STATE OF MAINE
DEPARTMENT OF TRANSPORTATION
16 STATE HOUSE STATION
AUGUSTA, MAINE

Subject: **Turner**
Federal Project No: STP-1277(700)S
State Pin No: 012777.00
Amendment No. 1

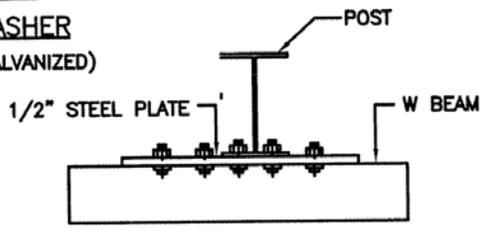
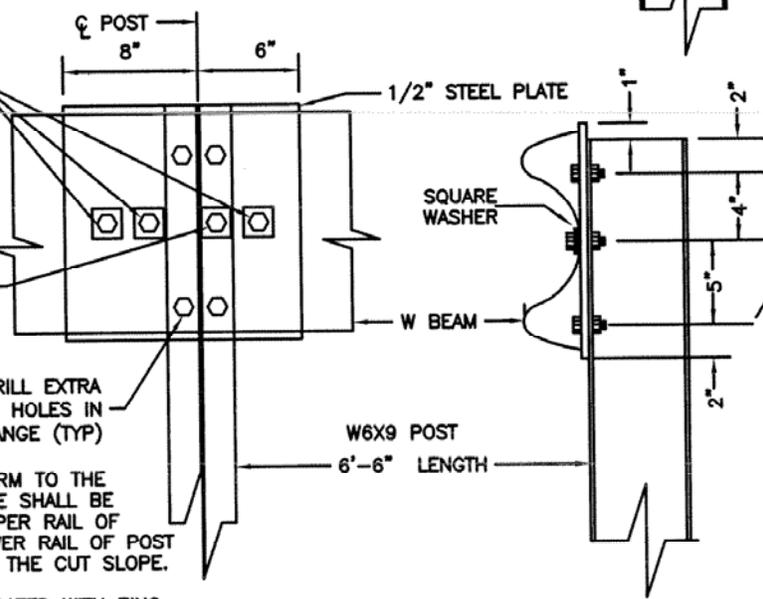
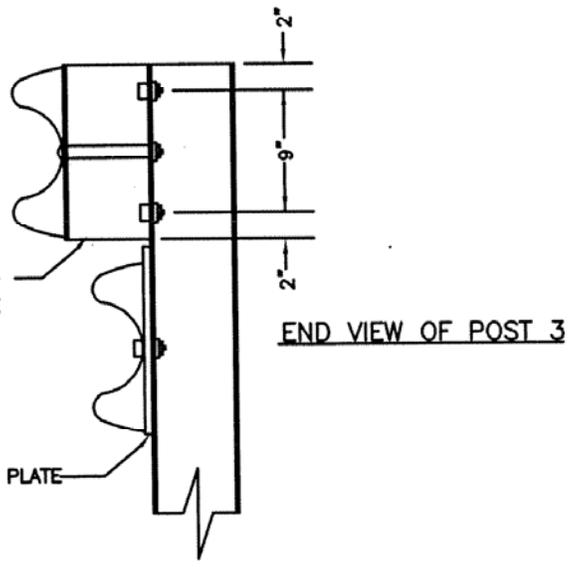
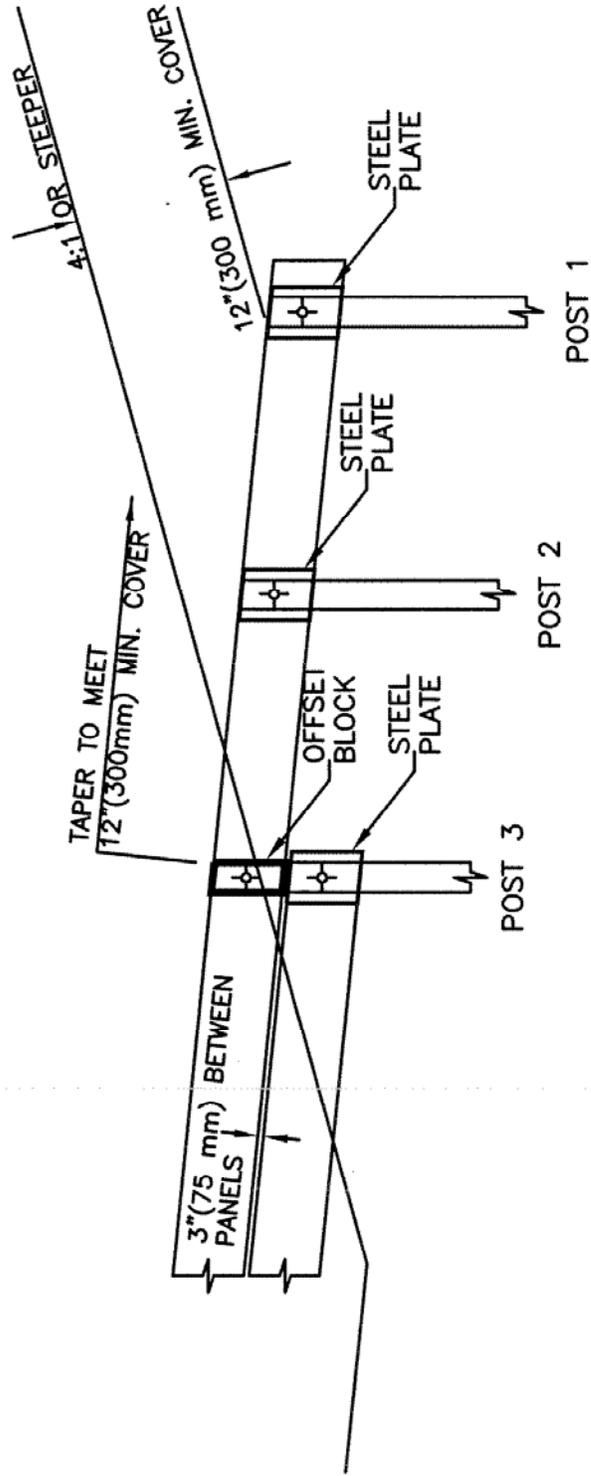
Question: On the buried end section, it calls for "modified Blocks", what does this mean? Also called for are 13 plates, what are these and where do they go?

Response: The blocks for the sections in question should be composite blocks and not wooden. Plates shall be used on the two buried posts and any posts where the rub rail will be required. This will be determined in the field. Payment for the buried rail Type A or B will be paid for under 606.23. Please see the attached detail.
